Fifth Gen Cascadia Turn Signal/DRL - Update

Customer Advisory Letter

Date: 07/14/2026
CAL FTL 54-043_REV1

Subject: 5th Generation Cascadia Headlamp Turn Signal Not Functioning

Headlamp assembly image showing new p/n

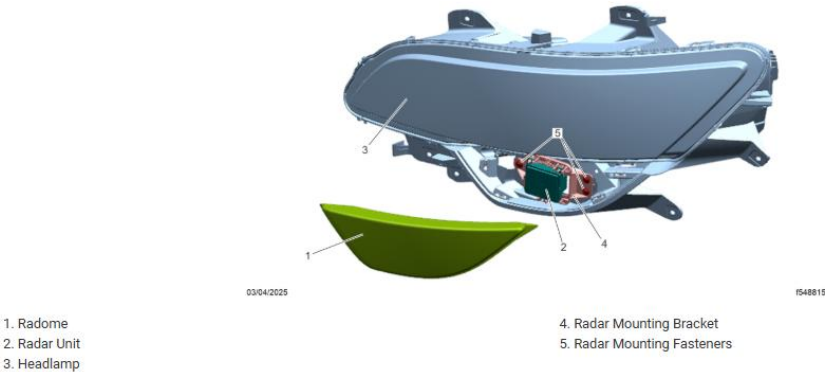
Status Update:
Solder improvement created a part number change from A66-20649-008/009 to 010/011 (blue)
New higher efficiency LED was implemented to use less current. This will be marked by deviation number PDNY01+D4
In short: p/n **A66-20649-010 or 011 w/ PDNY01+D4 is a good part** or A66-20649-012 or A66-20649-013 once they are available. These do not need replaced

Correction: Follow CAL 054-043. Make sure you have part before downing a truck.
Replace the headlamp assembly.
